## DRAFT WORKING PAPER

# Assessment of Possible Effects of Construction Blasting at Whites Point Quarry and Marine Terminal on Marine Mammals in the Bay of Fundy

Oct 25, 2005

Figure 1. Proposed Shot 1 Initial Sequence.

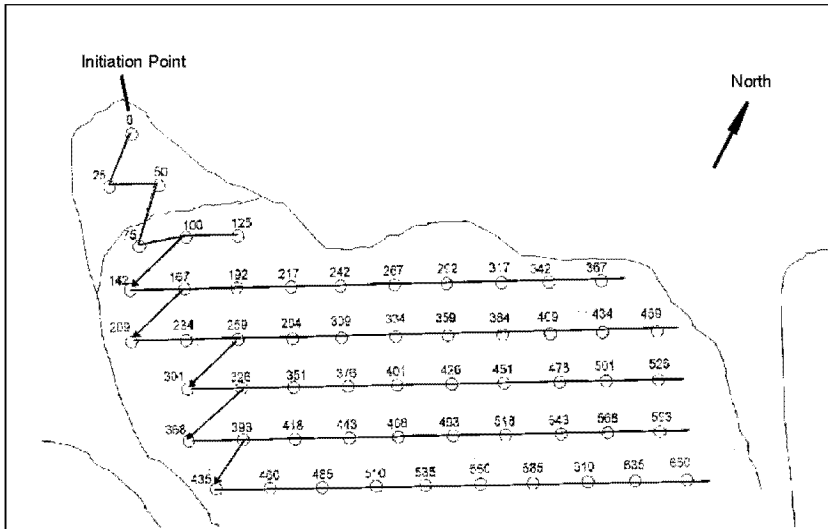
Beam forming of energy could occur whenever the sound propagation interval between any arbitrary pair of shot holes exceeds the pair-specific inter-hole delay time. Assuming a local propagation velocity of around 3 km/s, sound should propagate across the shot pattern largest dimension in about 10 ms or so. Therefore some degree of “beam forming” is still theoretically possible. However, preliminary examination does not indicate any instances where sound energy would be beamed straight at the nearest part of the coastline. In part, this may be due to the specific layout of the lines and the onset of the detonation sequence at the westernmost corner (see Figure 1).

The modification to produce a minimum of 8 ms delay between any two blasts over the entire pattern might be less effective than 25 ms delays but far better than no delays, i.e. simultaneous detonation of all shot holes.

At 500m range within the water column, successive pressure pulses at 8 ms separation may be sufficiently closely spaced to partially overlap; however, the main effect would be to extend the length of the resultant superimposed pulse rather than to increase its amplitude.
